Re: Florida Power & Light Company
Proposed Turkey Point Units 6 and 7
Docket Nos. 52-040 and 52-041
Voluntary Revised Response to NRC Request for Additional Information Letter
No. 040 (eRAI 6006) – Standard Review Plan Section 02.05.04 –
Stability of Subsurface Materials and Foundations

Attachment: FPL Revised Response to NRC RAI No. 02.05.04-16 (eRAI 6006)

SRP Section: 02.05.04 - Stability of Subsurface Materials and Foundations

NRC RAI Number: 02.05.04-16 (eRAI 6006)

Figure 1 Vertical RQD Variation

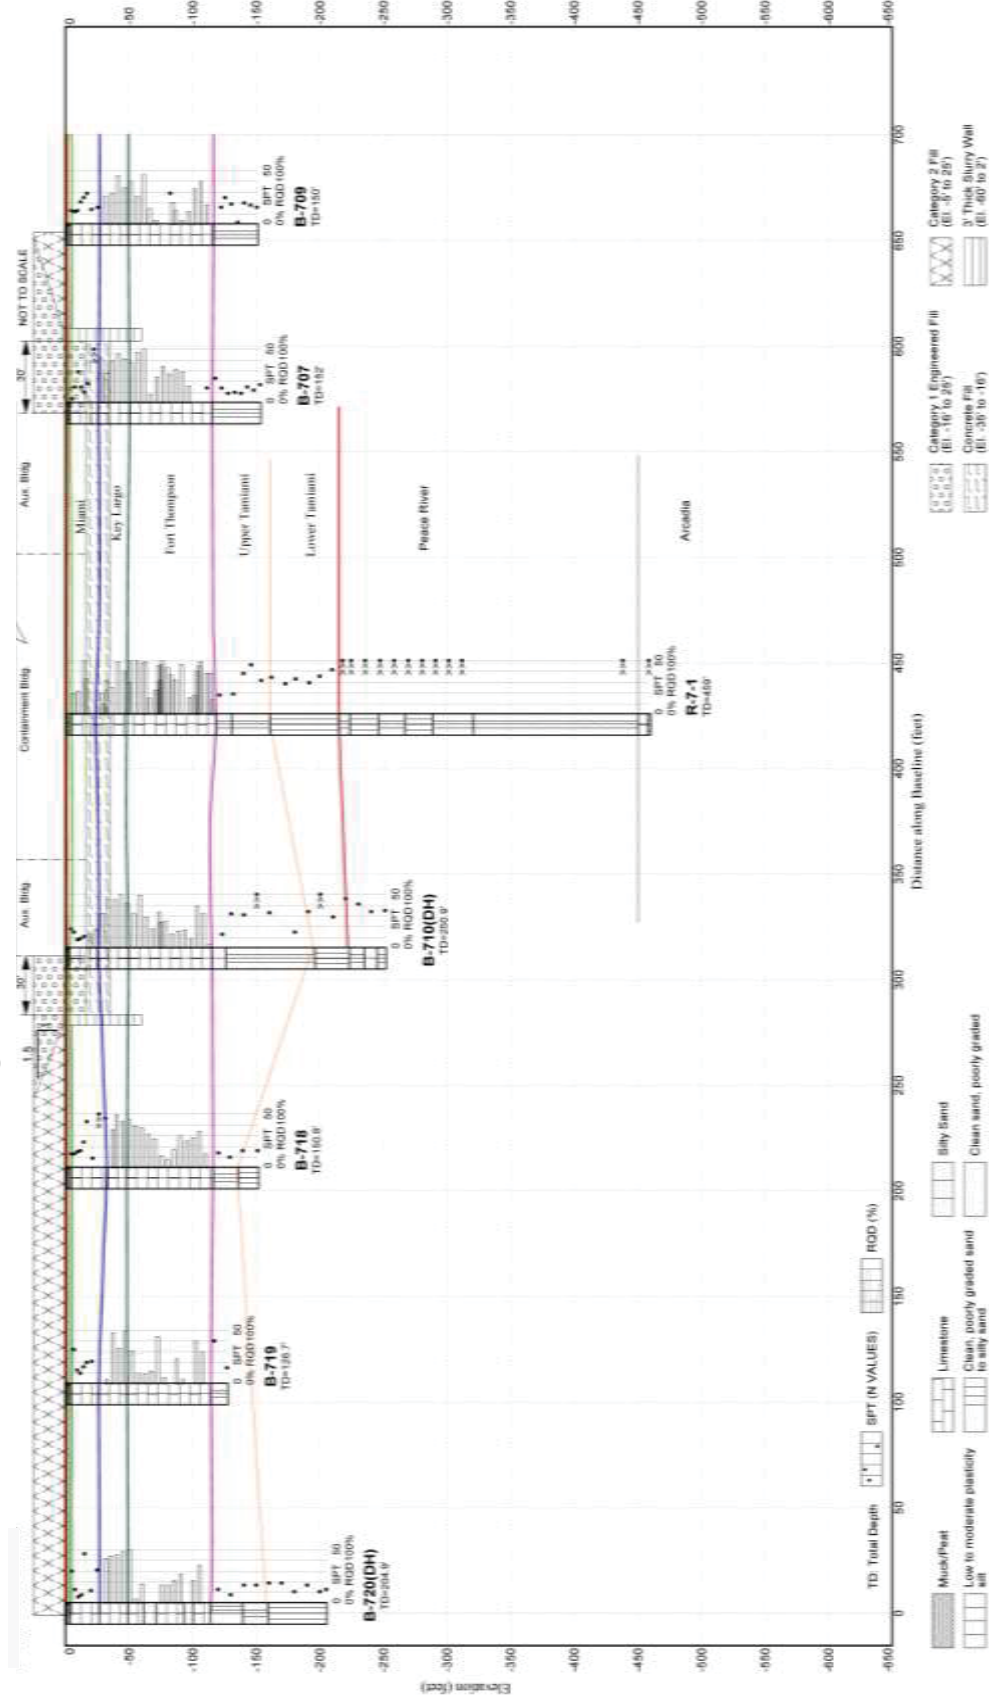
Section 2.5.4.7.3.3 "Shear modulus and Damping for Rock", indicates that the damping for rock is taken as 1%. The damping shown in Figure 2.5.2-249, which describes the soil properties used to develop the GMRS, indicates that a damping value of 0.5% was used in the analyses. In accordance with NUREG-0800, Standard Review Plan, Chapter 2.5.4, "Stability of Subsurface Materials and Foundations," please provide clarification as to the actual level of damping used in the analyses and provide a basis for its selection considering the large variability in RQD shown in Figure 2.5.4-215.

The variability in RQD within each stratum is generally random in nature and does not have directional trends (e.g., high RQD at the top of the stratum and low RQD at the bottom), thus, the strata are not sub-divided within each formation. Figure 1 shows vertical RQD variability in the boreholes of cross-section A-A (see Figure 2). The lateral variability for the Key Largo and Fort Thompson formations is presented in Figures 3 and 4. The natural variability, which is evident in Figures 1, 3 and 4, is addressed through a randomization process for site response analysis as described in FSAR Subsection 2.5.2.5.2.
